Access Compliance Report

Public Rights-of-Way

(Curb Ramps)

Intersection ID: 49140	Main Street: POPE_FARM_RD	Cross Street: CEMKEY_WAY_CT	Location: SE
ADA ID: C0B706BB72B2	Ramp Type: Perp	Initial Pass/Fail: Fail	Overall Compliance: No
Severity Score: 8.75			
Codes/Mitigation Info/Possible Solution		Field Measurements/Component Compliance

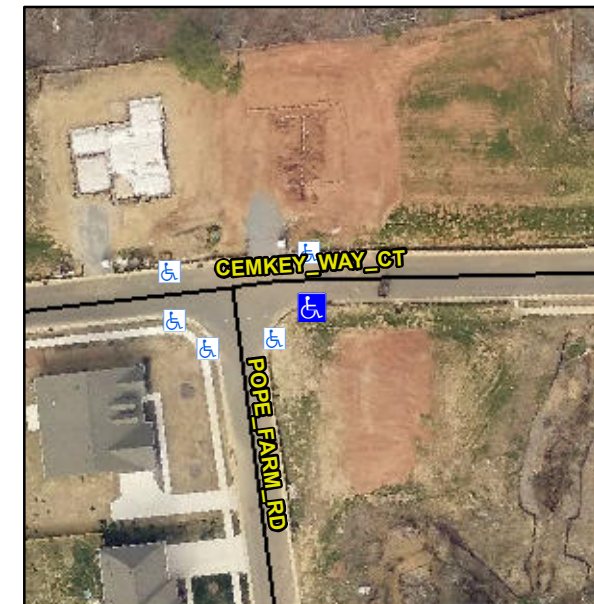
Not Found, R304.5.1

Compliance	Description	Data	Compliance	Description	Data
N/A	Ramp Length (in)	52.0	Yes	Ramp Slope (%)	7.2
No	Ramp Width (in)	47.0	Yes	Ramp XSlope (%)	0.5
N/A	Flare Type LT	N/A	N/A	Flare Type RT	N/A
N/A	Flare Slope LT (%)	N/A	N/A	Flare Slope RT (%)	N/A
N/A	Flare Traversable LT?	N/A	N/A	Flare Traversable RT?	N/A
N/A	Landing Length (in)	N/A	N/A	DWS Provided?	N/A
N/A	Landing Width (in)	N/A	N/A	DWS Contrast?	N/A
N/A	Landing Slope (%)	N/A	N/A	DWS Length (in)	N/A
N/A	Landing X Slope (%)	N/A	N/A	DWS Full Width?	N/A
N/A	Landing Curb? (Y/N)	N/A	N/A	DWS Offset (in)	N/A
N/A	Shared Landing?	N/A			
N/A	Gutter Ponding?	Yes	N/A	Gutter Slope (%)	N/A
N/A	Gutter Lip Ht (in)	N/A	N/A	Gutter X Slope (%)	N/A
N/A	Painted X Walk1?	No	N/A	Painted X Walk2?	N/A
	X Walk 1 Direction	To N		X Walk 2 Direction	N/A
N/A	X Walk 1 Width (in)	N/A	N/A	X Walk 2 Width (in)	N/A
	X Walk 1 Slope (%)	4.2		X Walk 2 Slope (%)	N/A
	X Walk 1 X Slope (%)	0.7		X Walk 2 X Slope (%)	N/A

Remove & Replace Entire Ramp.
